**BELLEVILLE COMBINED LICENSE APPLICATION – RESPONSE TO REQUEST FOR
ADDITIONAL INFORMATION – HAZARDS ANALYSIS**

Reference: Letter from Joseph Sebrosky (NRC) to Andrea L. Sterdis (TVA), Request for
Additional Information Letter No. 036 Related to SRP Section 02.02.03 for the
Belleville Units 3 and 4 Combined License Application, dated June 9, 2008

Subject: Hazards Analysis in the Final Safety Analysis Report

Figure 2.2-203
Spill Frequency of Combustible Material on the Tennessee
and Associated Major Rivers of Alabama, 2001-2004

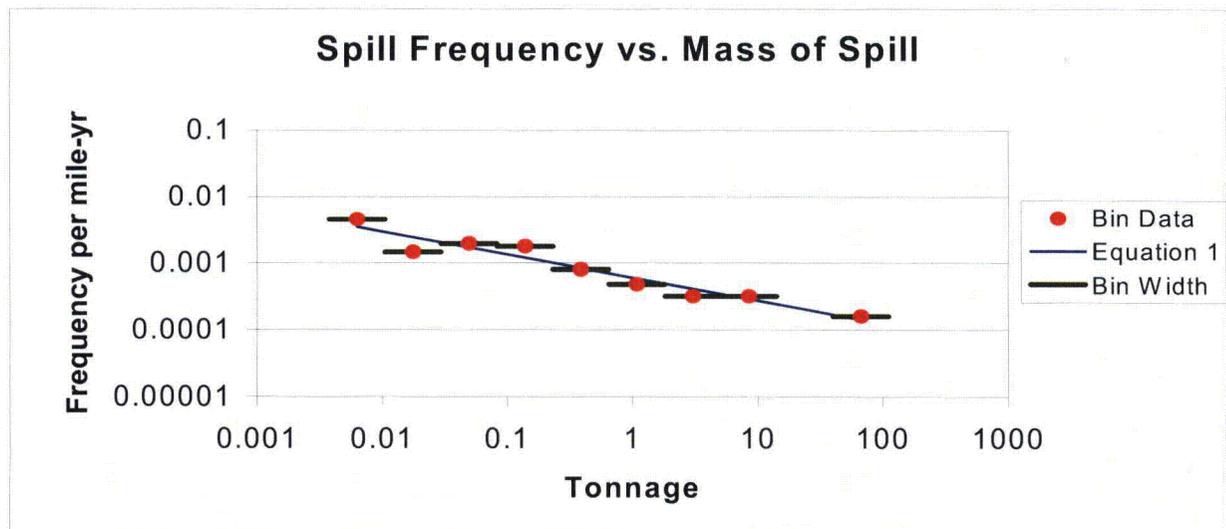
FSAR Tables 2.2-209, 2.2-210, and 2.2-211 identify commodities transported via the Tennessee River near the proposed site. The application mentions (page 2.2-13) that the applicant assessed potential hazards from explosive cargo transported past the proposed site via barge on the Gunter's Reservoir and that "initial screening of hazardous commodities eliminated all but two...". Which of the commodities/chemicals listed in the above-referenced tables were considered for screening? (Relatedly, please clarify why the two chemicals selected for further analysis, styrene and ethanol, are not listed in the tables.) Please clarify what bases, bounding assumptions, amounts, release rates, frequencies, traffic statistics, and other data TVA used in determining the safe standoff distances resulting from explosion, vapor cloud explosion, and probability presented.

The data in FSAR Table 2.2-219 is plotted on a log-log chart (FSAR Figure 2.2-203), and a linear curve fit was made giving the form:

$$\text{Spill Frequency (spills per mile-yr.)} = f = 10^{(-0.3431 * \text{Log}(\text{spill tonnage}) - 3.1743)}$$

4. COLA Part 2, FSAR, Chapter 2, Section 2.2, will be revised to add new Figure 2.2-203 as shown below:
